Service Bulletin

Bulletin No.: 19-NA-123

Subject: Rear Closure Hands Free Lamp Logo Projection Distorted

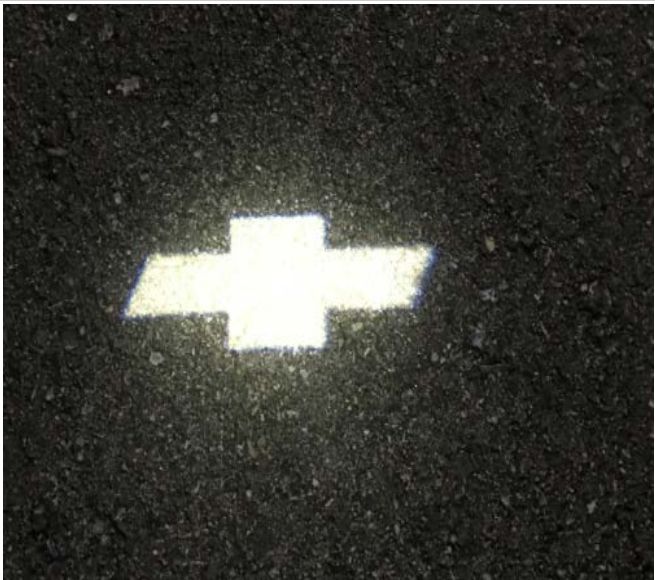
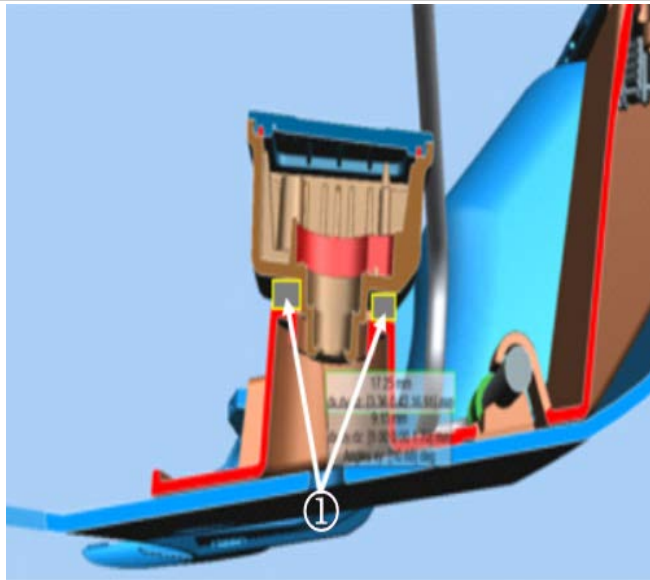
<p>Condition</p>	<div data-bbox="683 153 1333 728"></div> <div data-bbox="1419 739 1484 756"><p>5343103</p></div> <p data-bbox="540 768 1471 821">Note: The projected logo shows where the hands free kicking motion is to take place. An example is shown above.</p> <div data-bbox="683 835 1333 1411"></div> <div data-bbox="1419 1421 1484 1438"><p>5343106</p></div> <p data-bbox="540 1451 1455 1528">Some customers may comment that the on-ground image of the rear closure hands free lamp logo projection is distorted, and does not resemble the Chevrolet Bow Tie. Some further comment that the logo lamp resembles a 'C' or a circle.</p>
<p>Cause</p>	<p data-bbox="540 1539 1438 1591">The cause of the condition may be water entering between the rear closure hands free lamp and lamp bracket, and gathering onto the lens of the lamp.</p>

5343112

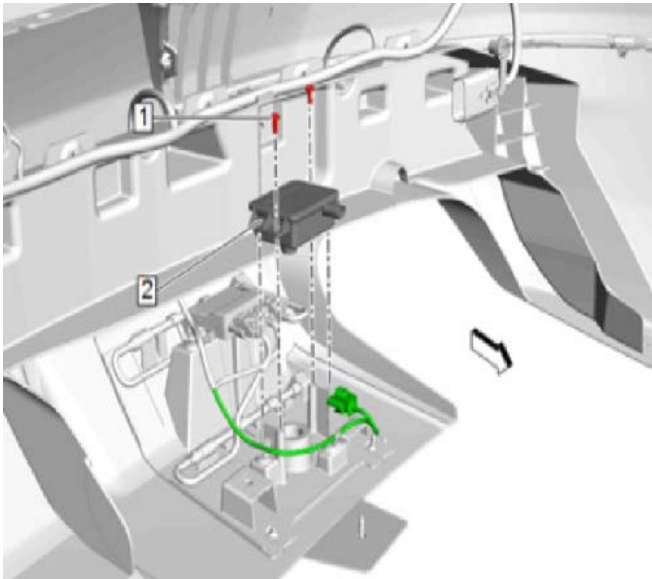
Note: The illustration above shows a cross-section of the seal installed (1), which results in blocking the main water path.

Following the steps in the Service Procedure below, add the service part foam seal referenced in the Part Table.
